STATE OF OREGON WATER SUPPLY WELL REPORT (as required by ORS 537.765 & OAR 690-205-0210)

WELL LABEL # L 4859

FINAL ORDER

REQUEST FOR WRITTEN APPROVAL TO USE CONSTRUCTION METHODS NOT INCLUDED IN OREGON ADMINISTRATIVE RULES 690-200 THROUGH 690-240

- (7) Diagram showing the pertinent features of the proposed well design and construction: (attach additional pages if needed)

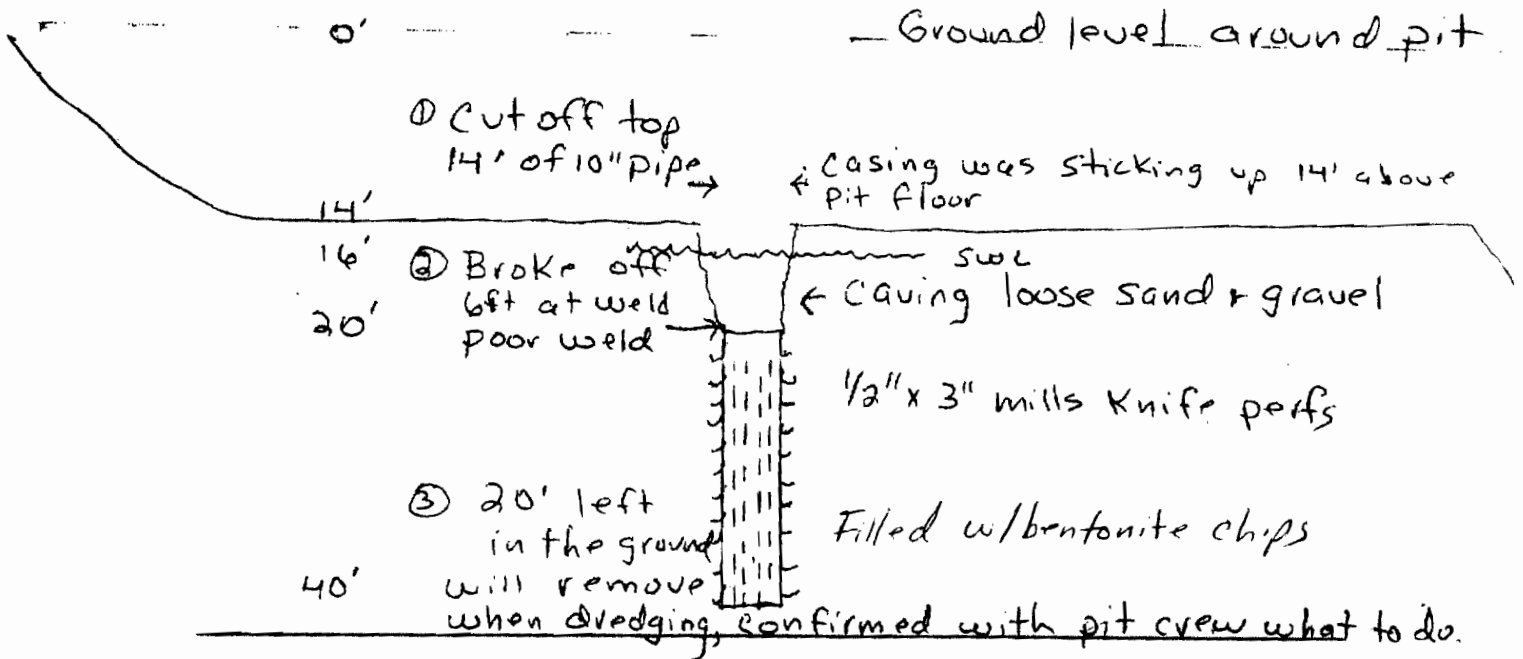
(5) The unusual site conditions which necessitate this request: Casing broke
off while trying to pull out. Pit depth
14 feet. Broke off 6' below ground. Left in 20 feet.

(6) The proposed construction methods that the bonded well constructor believes will be adequate for this well: (attach additional pages if needed)

The area around this well is currently
being mined out. The depth of the pit
once mining is complete will be below
the existing depth of the well. The section
of casing will be removed by the dredge.

The Special Standard request you submitted for owner: Knife River, Start Card number 200719, is hereby approved for the following: You may abandon this water well in place by verifying that it is clean to the natural bottom and then filling it from the bottom up with unhydrated bentonite chips. This is necessary due to the fact that the well is in an active mining pit. This Special Standard was verbally approved on December 31, 2008. Your Special Standard request form is enclosed. All other standards must be adhered to.
